**NOTICE OF ADDENDUM**  
**ADDENDUM NO. 3**

**CONTRACT NO. 7951**  
**Capitol East District Parking Structure**

This addendum is issued to modify, explain or correct the original Drawings, Specifications, or Contract Documents of the subject contract and is hereby made a part of the contract documents.

1 FIRST LEVEL PARKING / FIRST FLOOR COMMERCIAL PLAN  
1/8" = 1'-0"

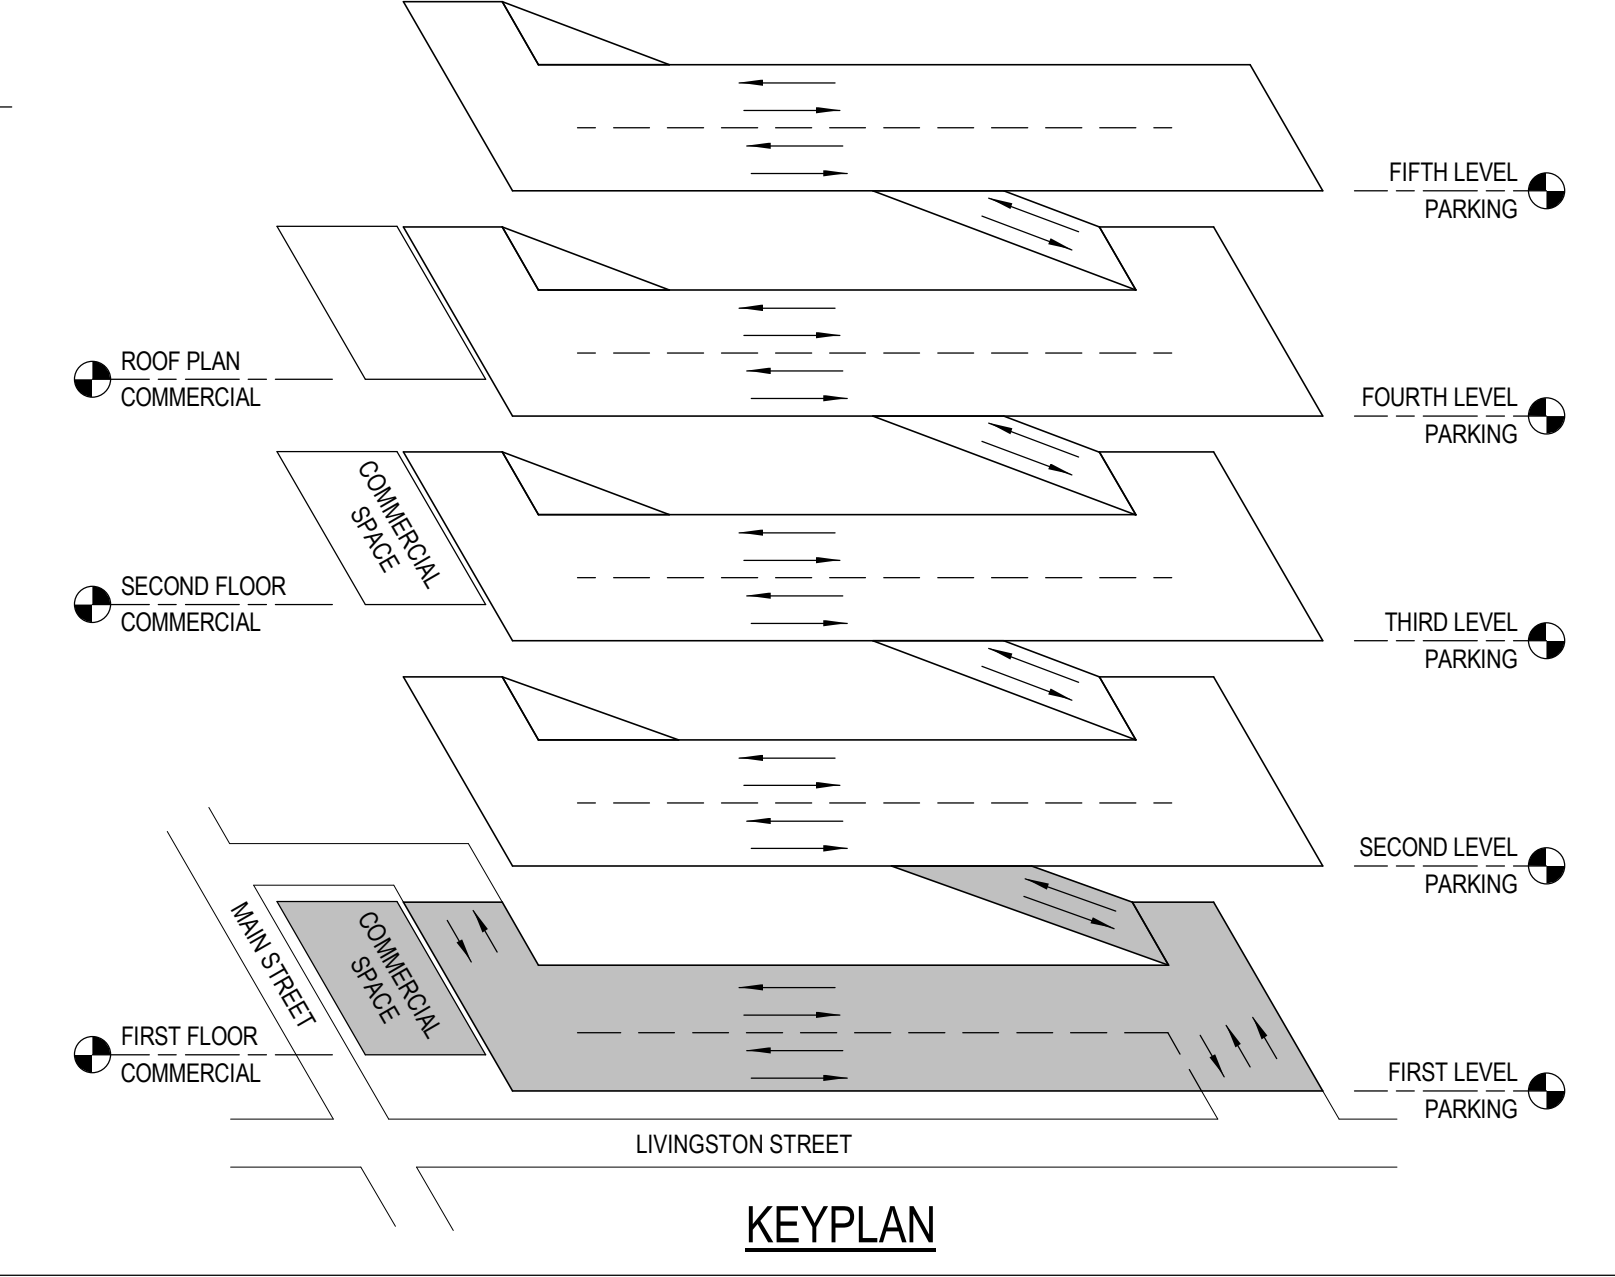
- A. FP-101 First Level Parking – First Floor Commercial Plan (Reissued)
  - ix. Revised location of standpipe at Column B/12.
- B. FP-102 Second Level Parking Plan (Reissued)
  - x. Revised location of standpipe at Column B/12.
- C. FP-103 Third Level Parking – Second Floor Commercial Plan (Reissued)
  - xi. Revised location of standpipe at Column B/12.
- D. FP-104 Fourth Level Parking – Commercial Roof Plan (Reissued)
  - xii. Revised location of standpipe at Column B/12.
- E. FP-105 Fifth Level Parking Plan (Reissued)
  - xiii. Revised location of standpipe at Column B/12.

**B1** BELOW SLAB PLUMBING PLAN  
1/8" = 1'-0"

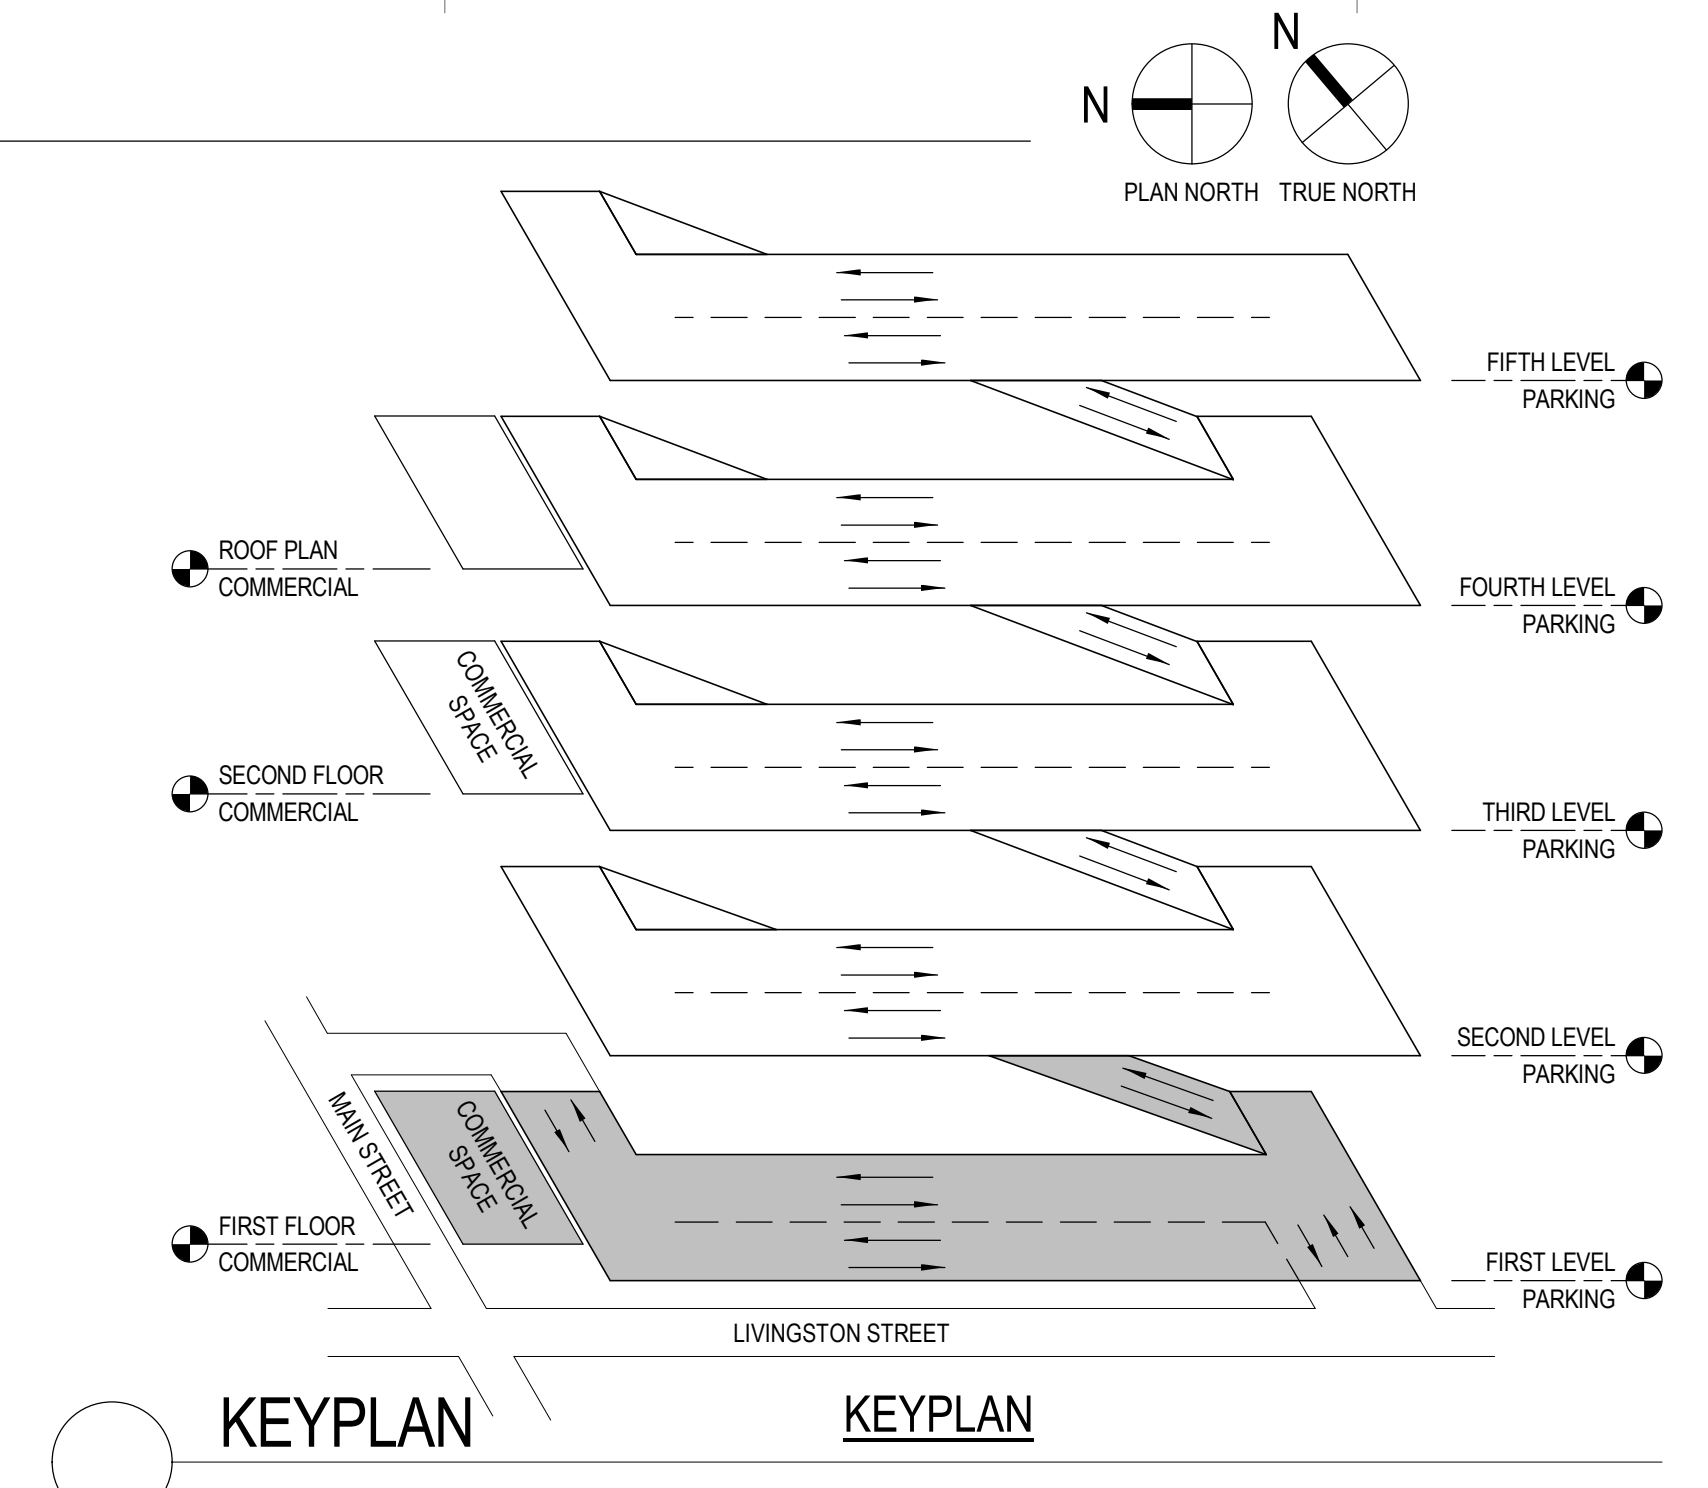
Q34: 15" PVC does not exist; the plan says it has a max GPM of 1615 which a 12" PVC pipe can handle a max GPM of 2,090 at an 1/8" per foot please clarify the storm size existing the building

- F. P-100 Below Slab Plumbing Plan (Reissued)
  - xiv. Revised location 15" drain line for catchment basin
  - xv. Revised location of deck drain, DD-1 at the east side of Column Line B/4
- G. P-104 Fourth Level Parking – Commercial Roof Plan (Reissued)
  - xvi. Revised location 6" Primary Storm and Overflow storm drain lines
- H. P-601 Plumbing Isometric (Reissued)
  - i. Revised location 15" drain line for catchment basin
  - ii. Revised location of deck drain, DD-1 at the east side of Column Line B/4
  - iii. Revised location 6" Primary Storm and Overflow storm drain lines

**A34: Change reference to the 15" PVC to 16".**
